Project
WATERLOO METRO QUARTER DEVELOPMENT

Sheet title
General Arrangement Plan
Level 01

Status	Revision
AFT D&C Builder	0
Sheet number	Revision
WMQ-BLD4-BSA-AR-DRG-DA101	0

Roof Plan

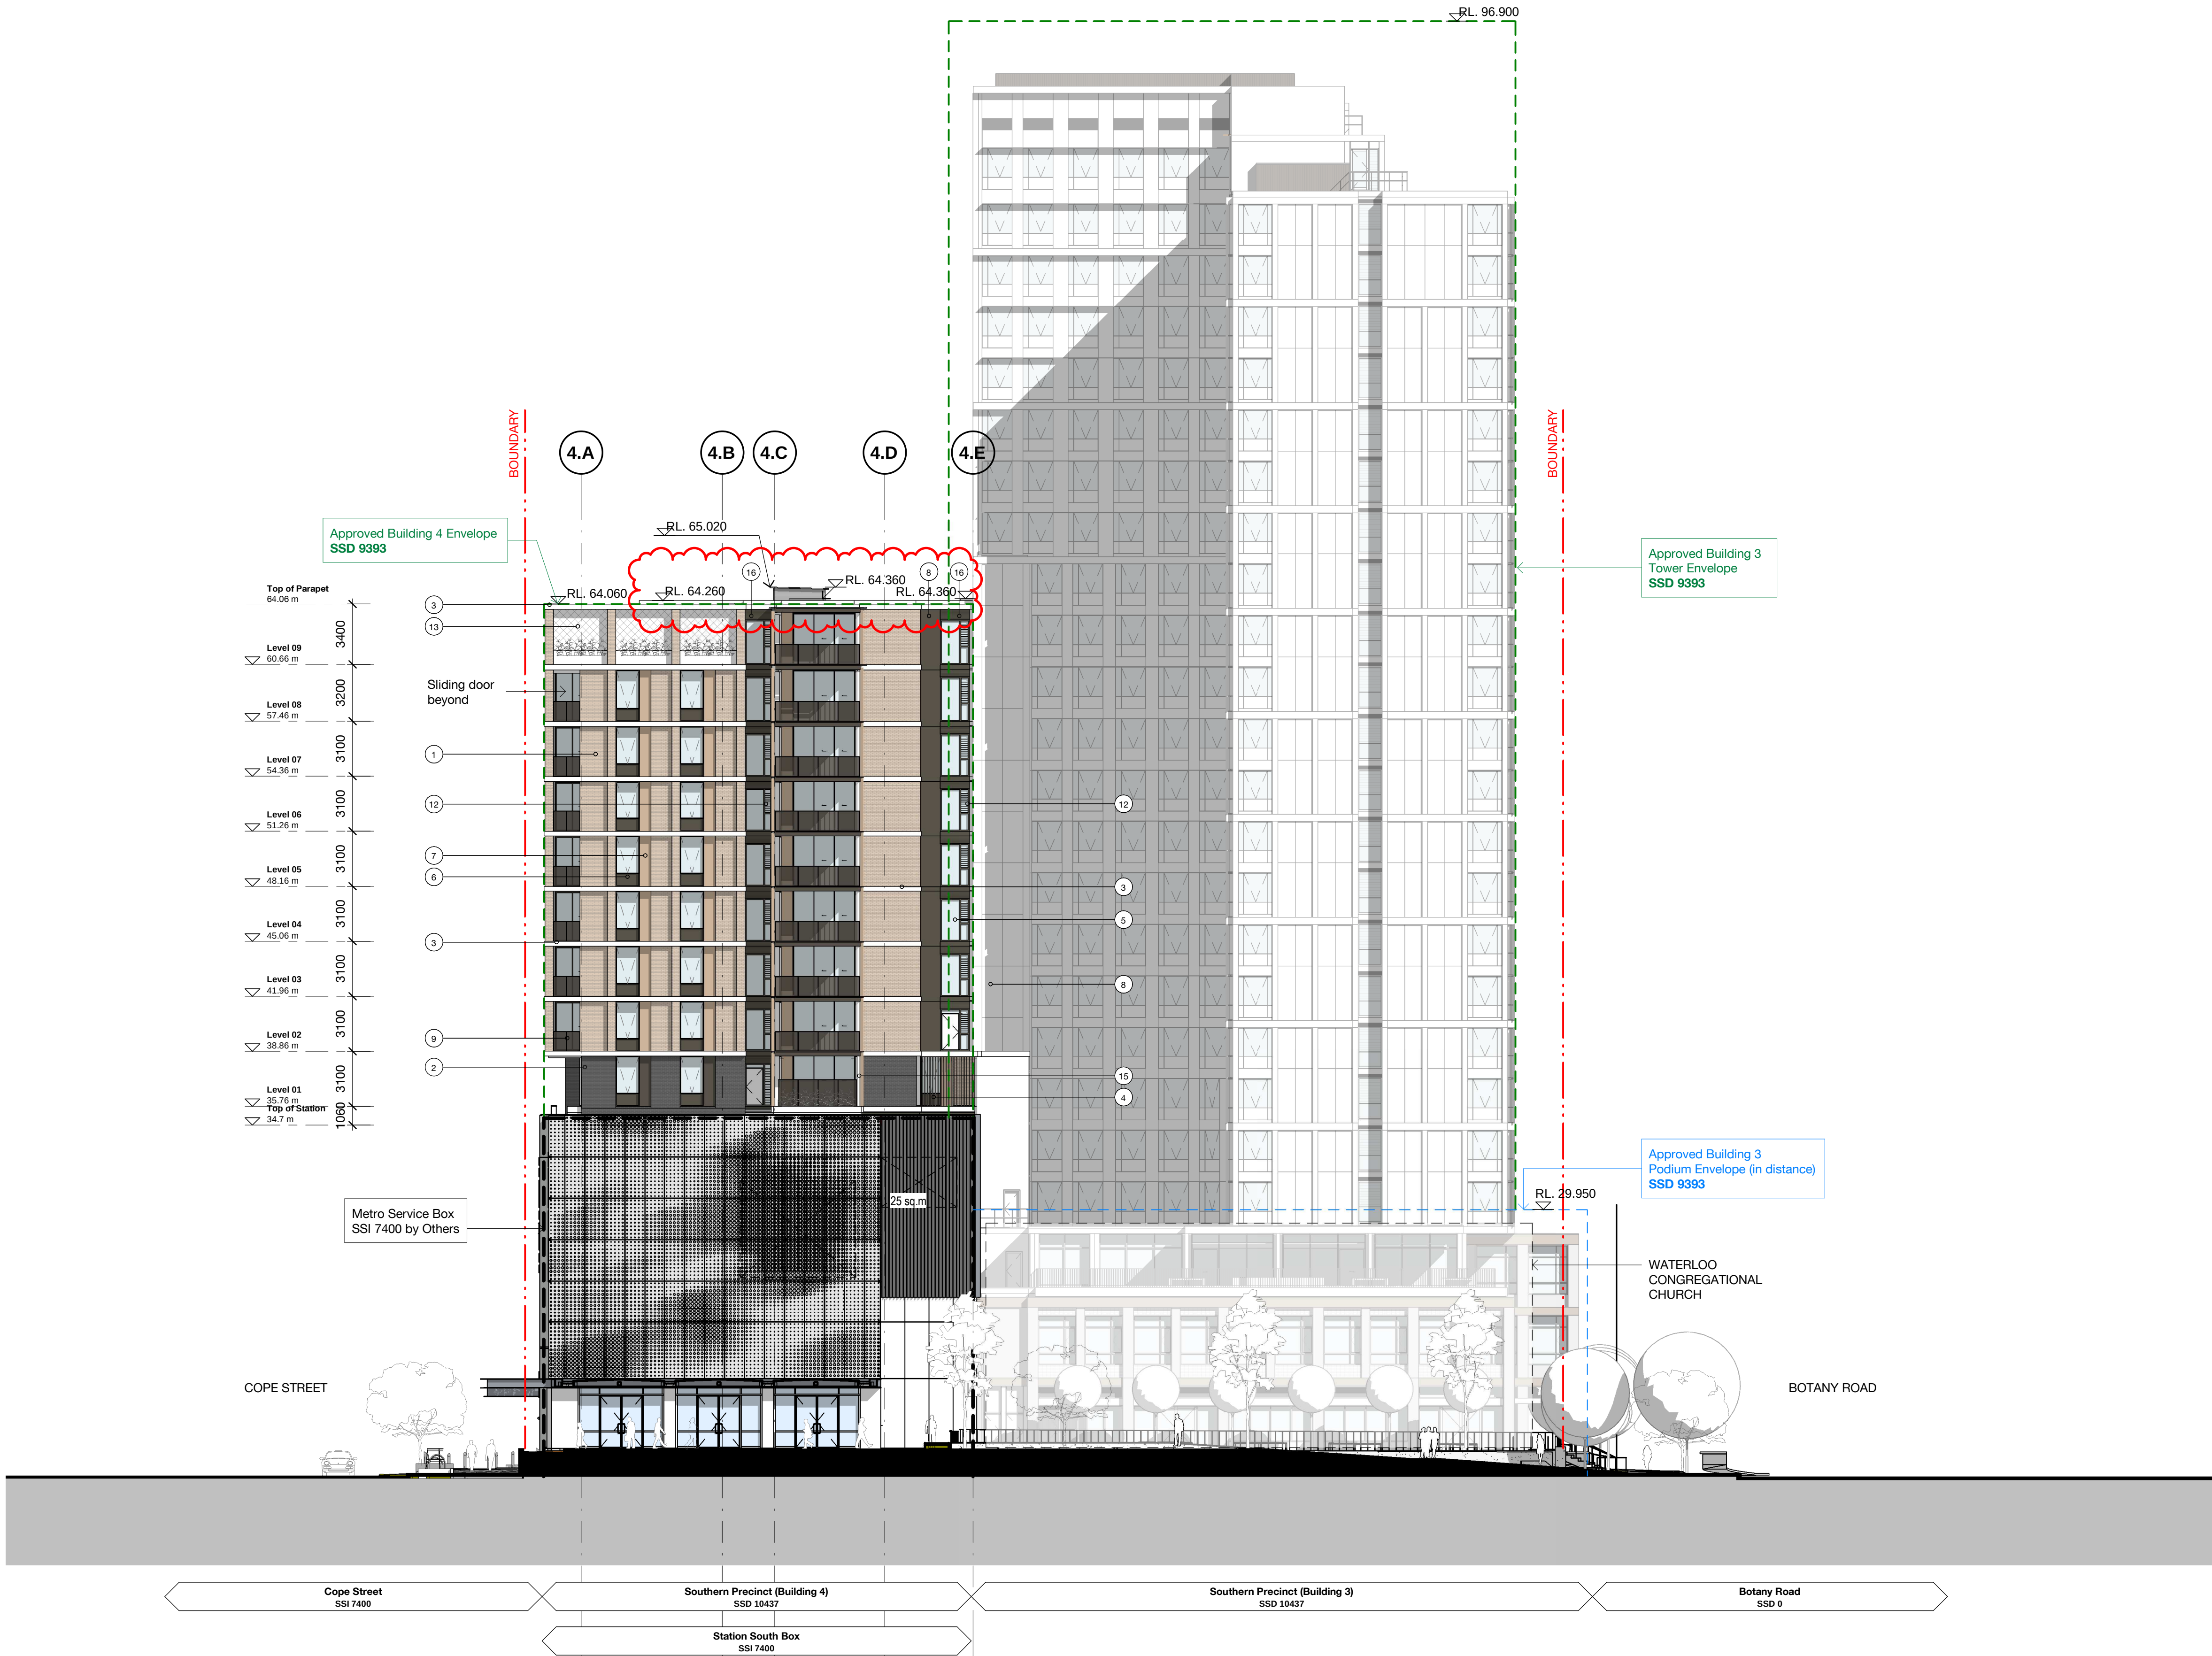
- Changes for Return to submission
- Roof parapet
 - Terrace pergola
 - Addition of Roof Plant Enclosure

Sheet title
Elevation North

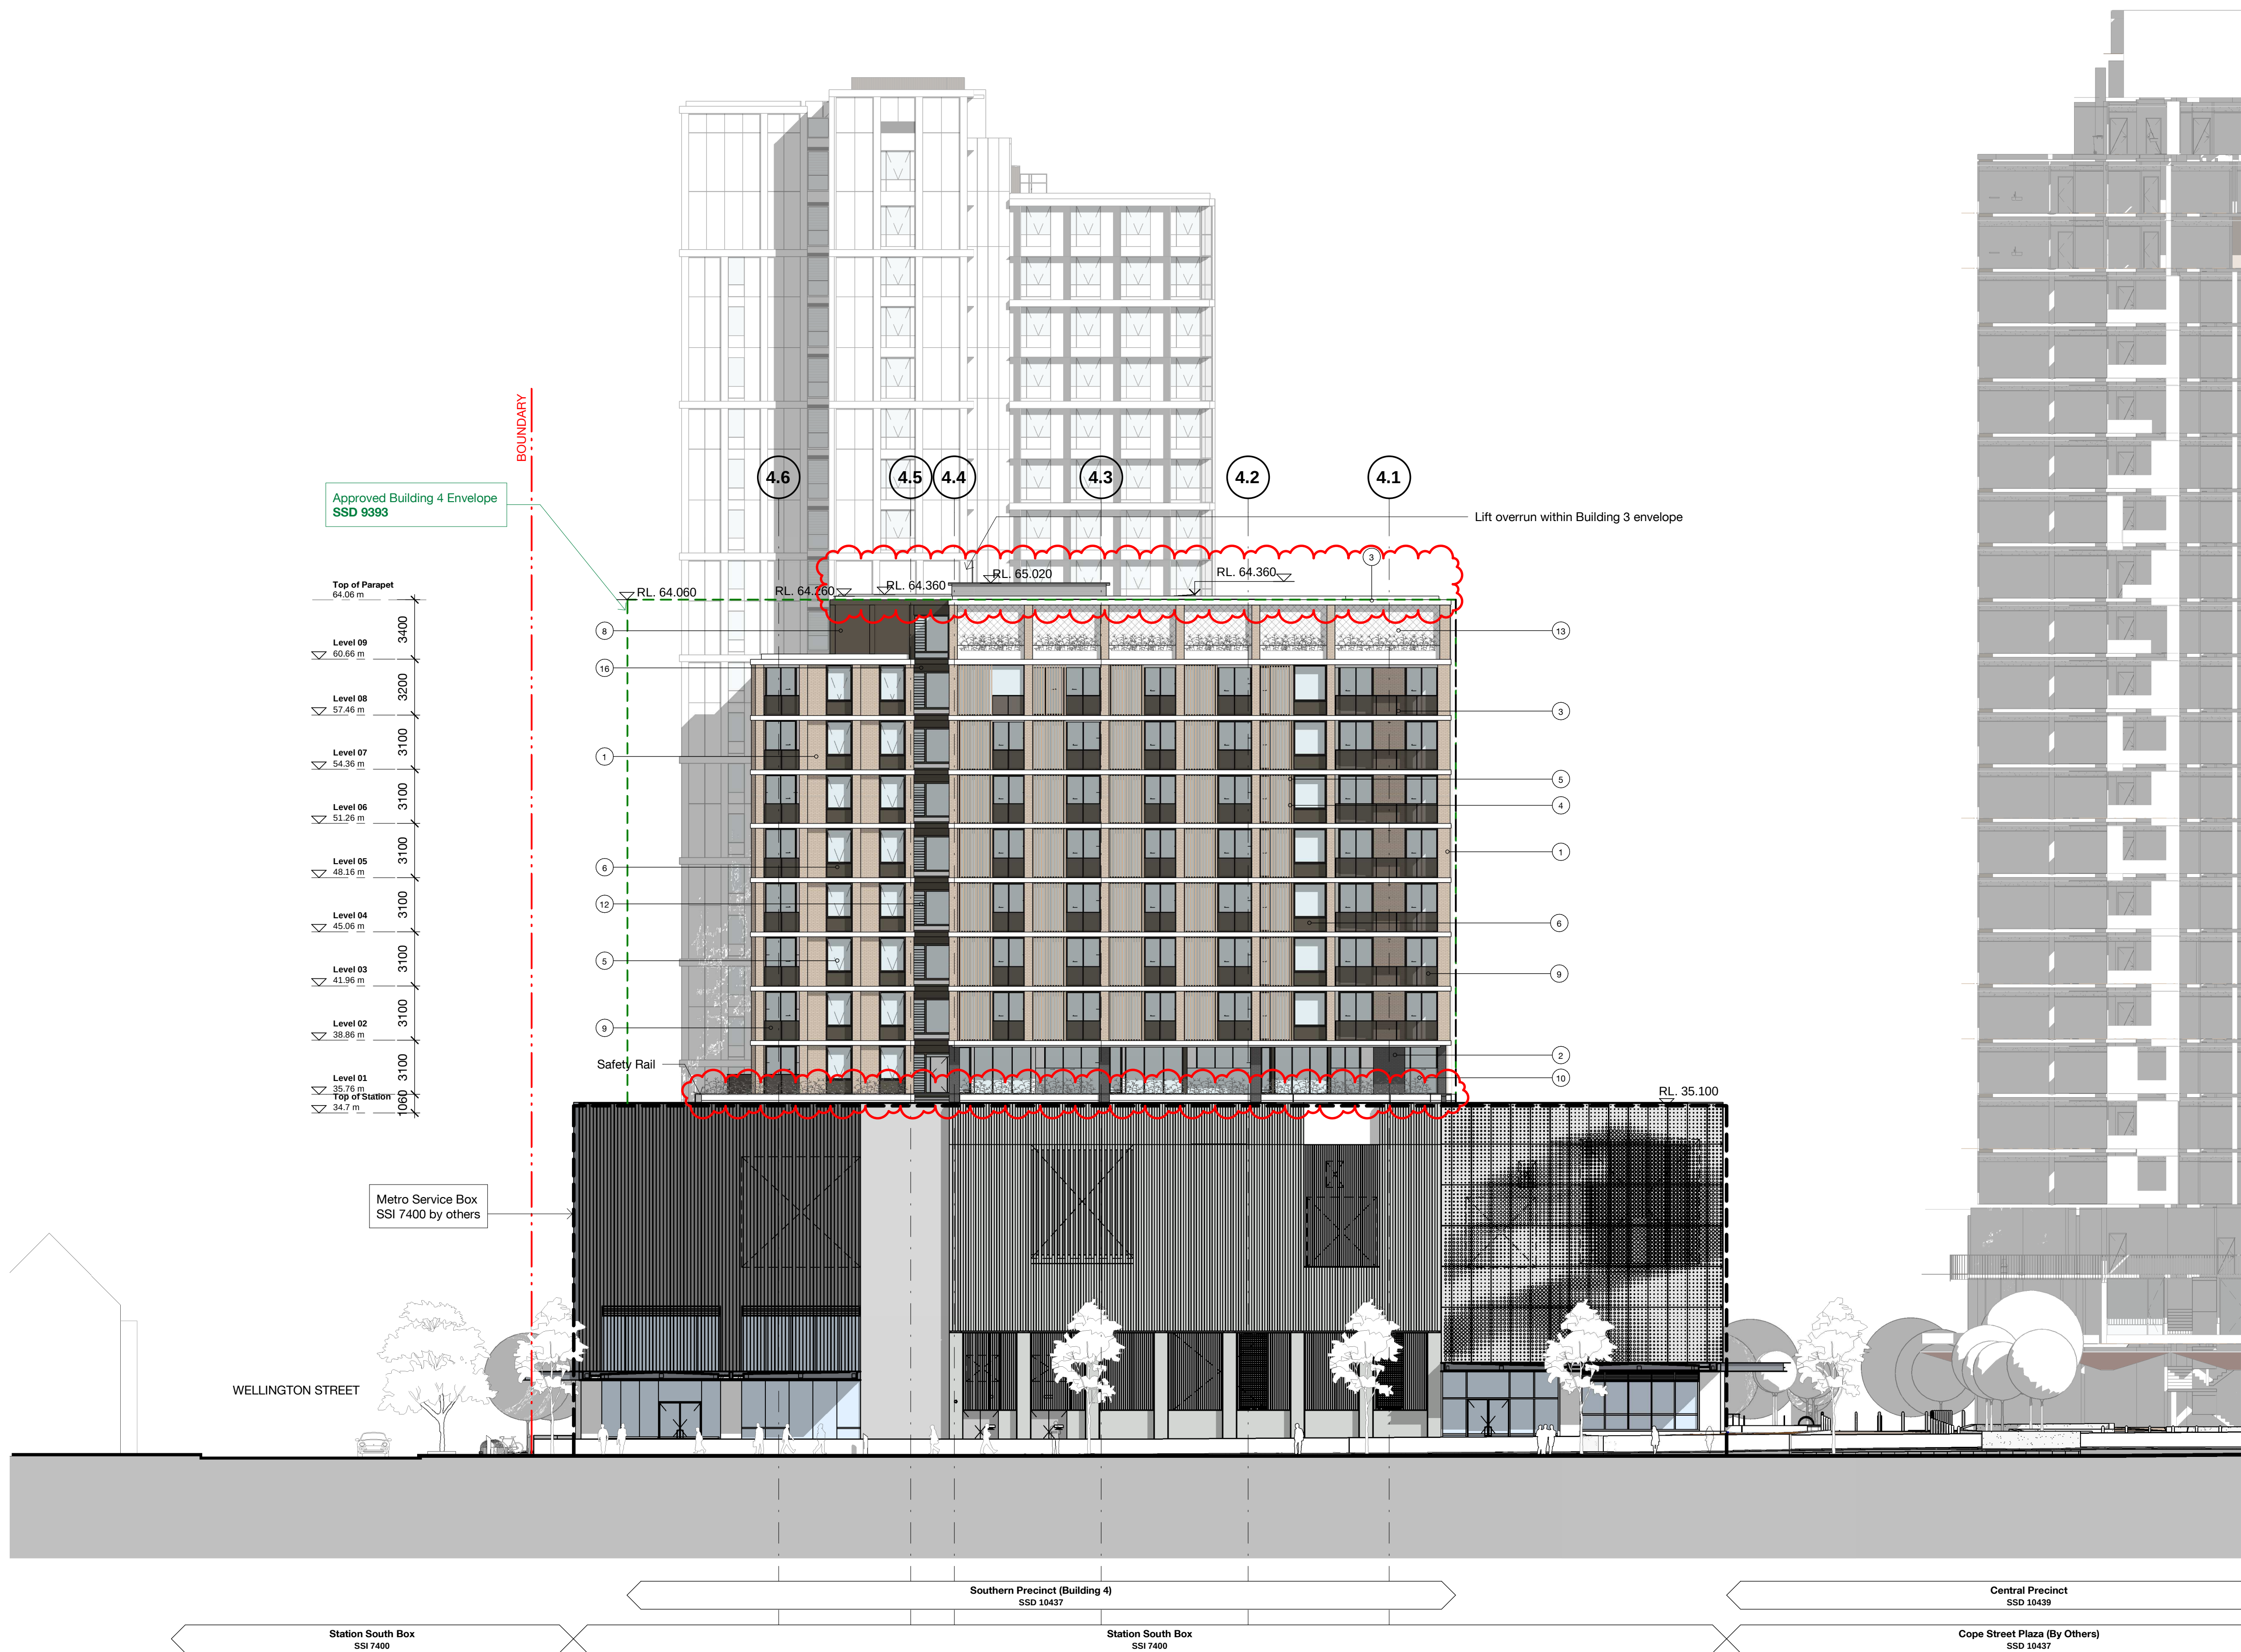
- Changes for Return to submission**
- Addition of Roof Plant Enclosure
 - Roof parapet

Elevation East

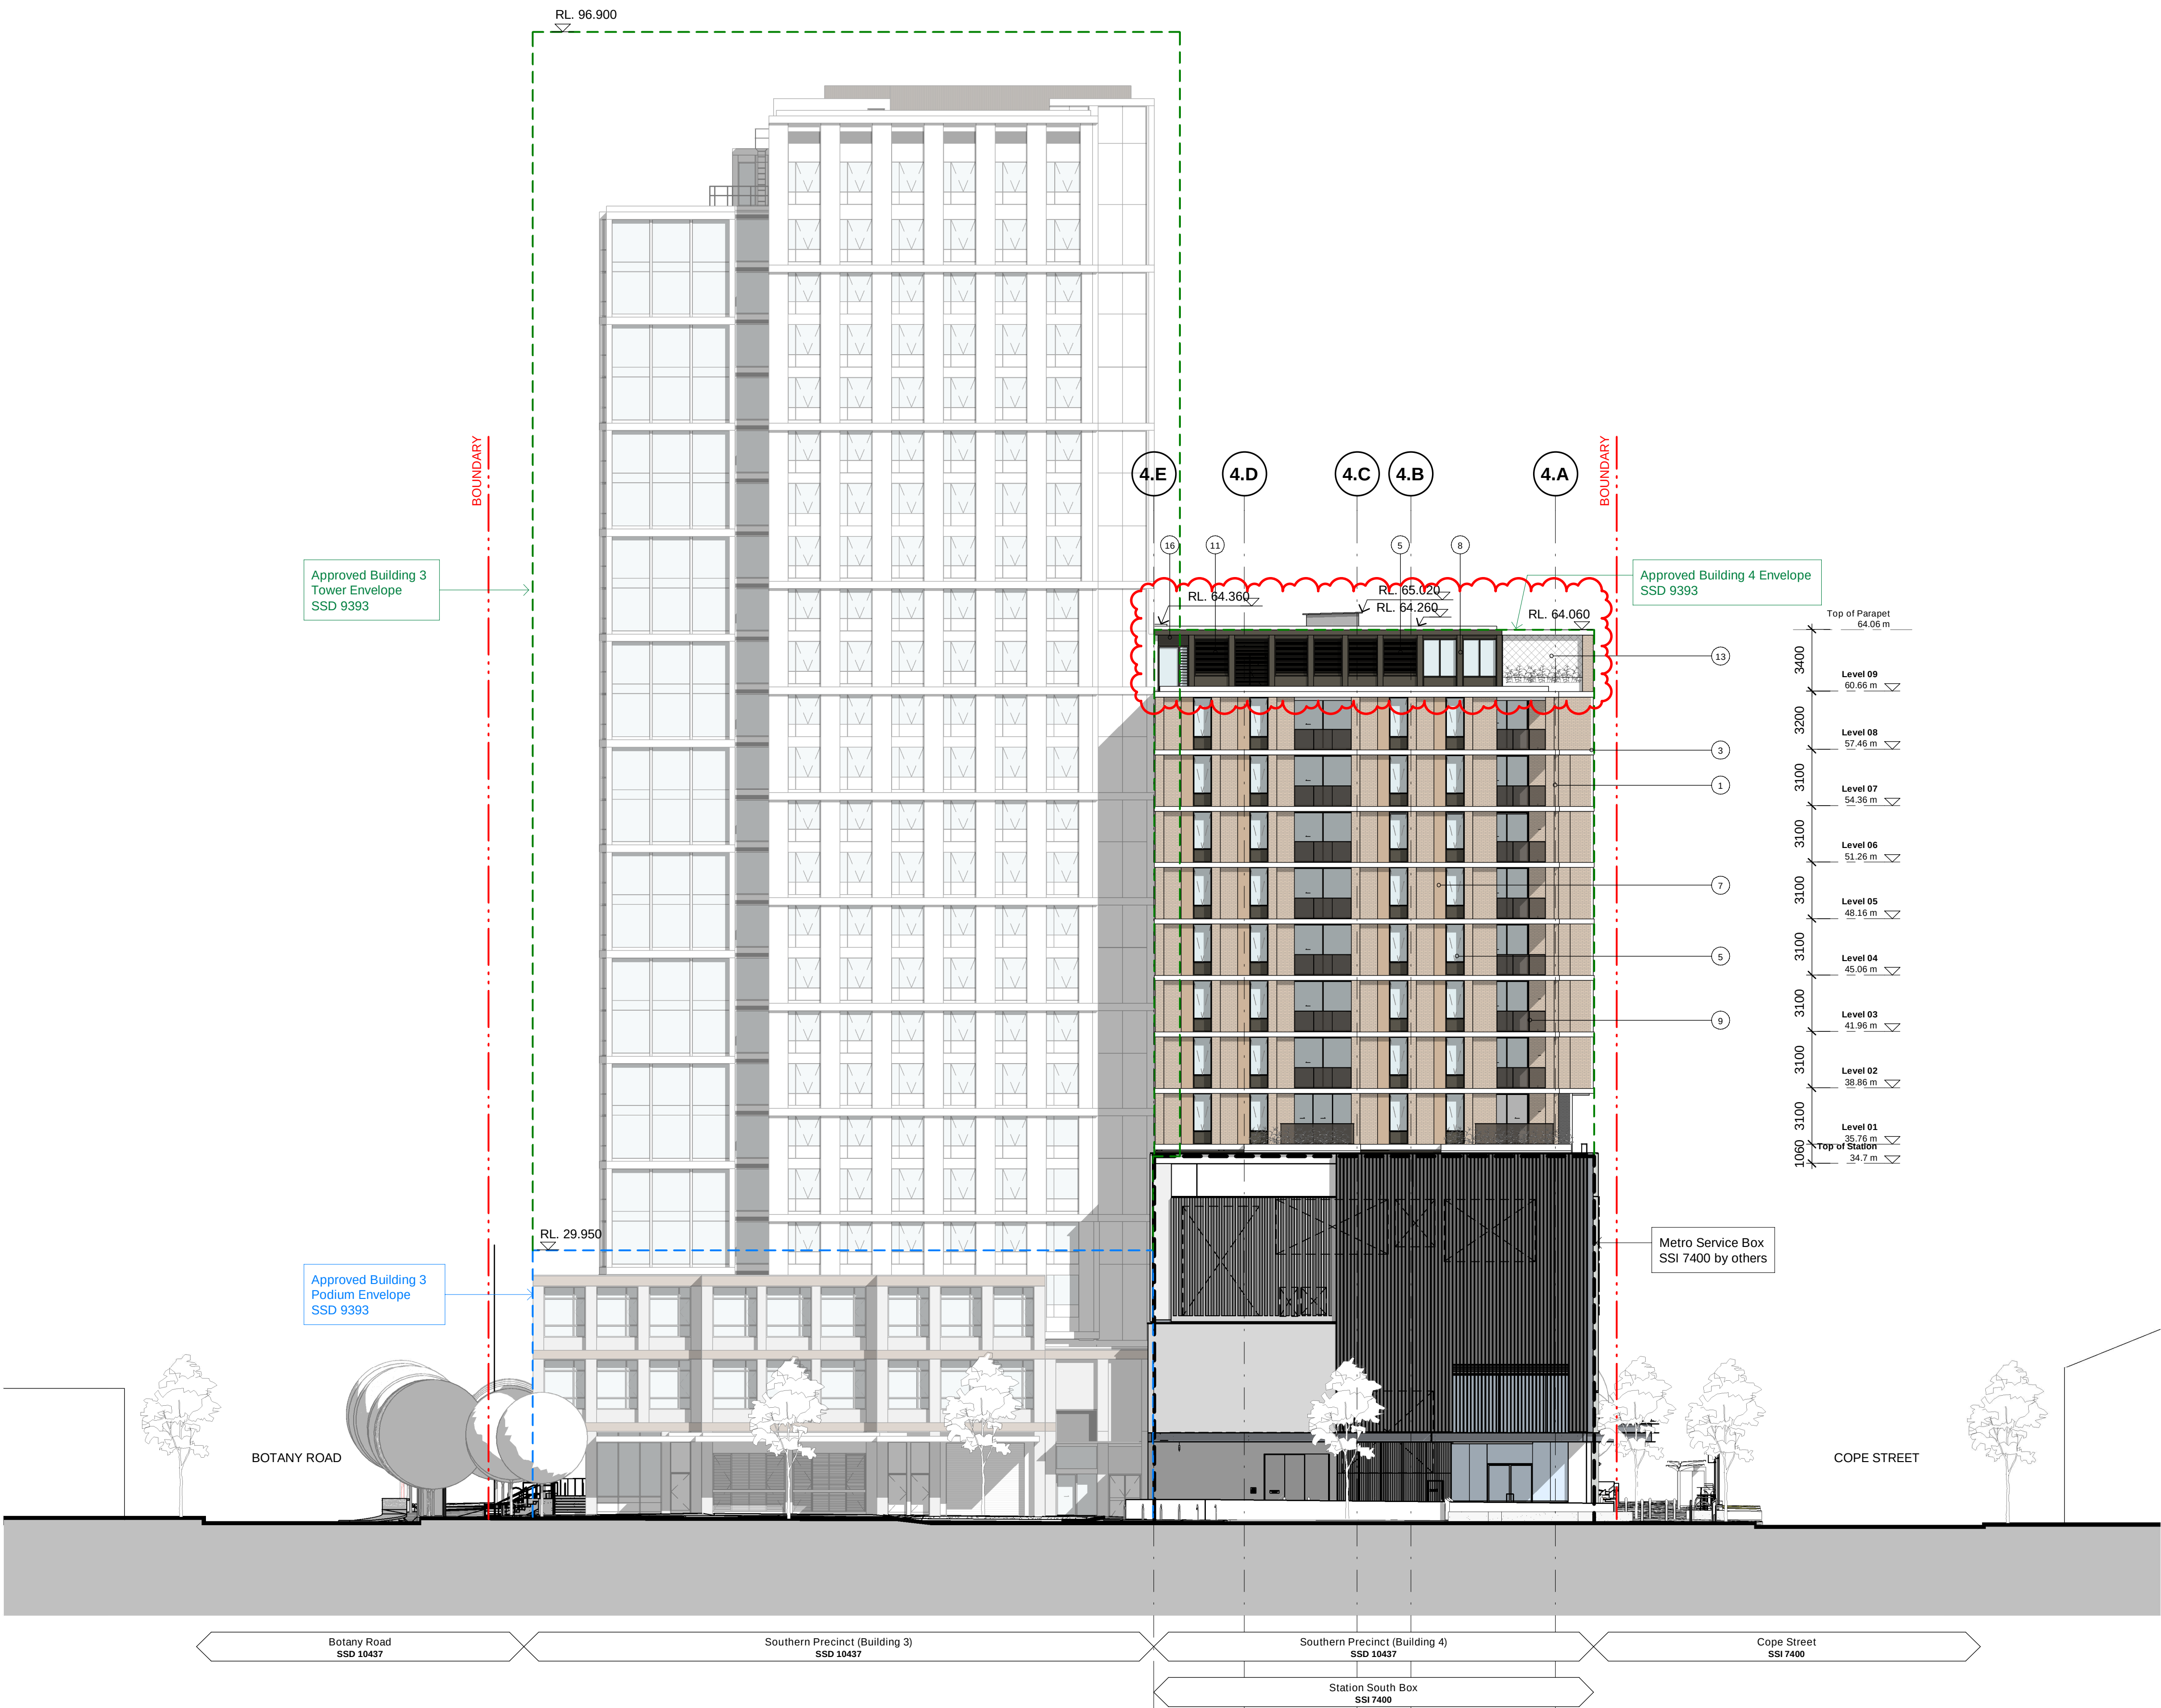
- Addition of Roof Plant Enclosure
- Roof parapet
- Addition of safety rail on station roof
